| 8802-3/802.3 REVISION REQUEST 1217 |

REQUESTED REVISION:
STANDARD: IEEE 802.3av-2009
CLAUSE NUMBER: 76.2.2.3
CLAUSE TITLE: Dual-rate mode

Figure 76-4—PCS and Reconciliation Sublayer for dual rate mode at OLT

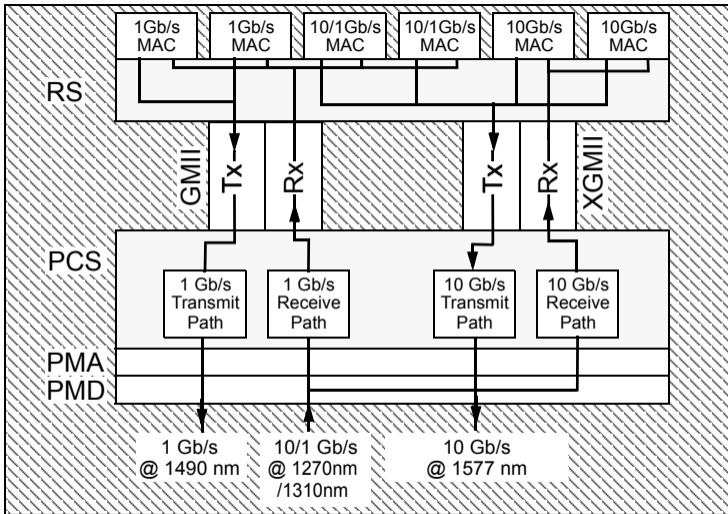
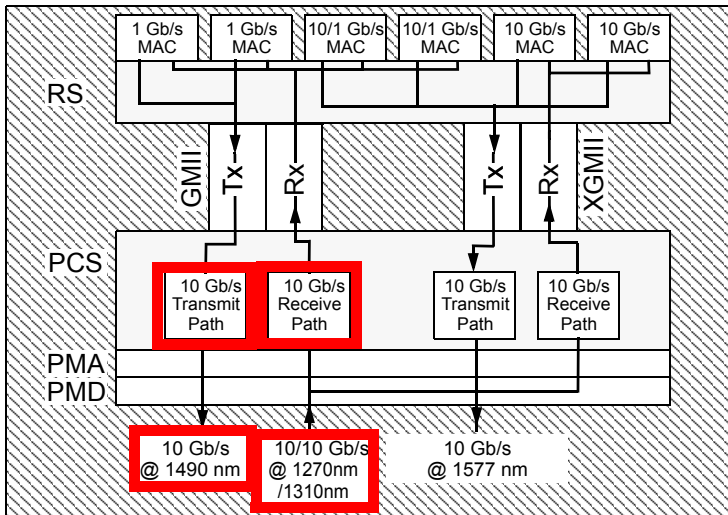
PROPOSED REVISION TEXT:
In IEEE 802.3av-2009, Figure 76-4 - 'PCS and Reconciliation Sublayer for dual rate mode at OLT' contains four numeric errors, as marked in red boxes in file 'Figure 76-4 in 802.3av-2009.pdf'.
Box 1 (top row, leftmost): '10 Gb/s' should read '1 Gb/s'
Box 2 (top row, rightmost): '10 Gb/s' should read '1 Gb/s'
Box 3 (bottom row, leftmost): '10 Gb/s' should read '1 Gb/s'
Box 4 (top row, rightmost): '10/10 Gb/s' should read '10/1 Gb/s'
Correct figure is included in the file 'Figure 76-4 in 802.3av D2.0.pdf'.

RATIONALE FOR REVISION:
This figure is technically incorrect and needs to be updated to a correct version prior to release of IEEE Std 802.3-2011.
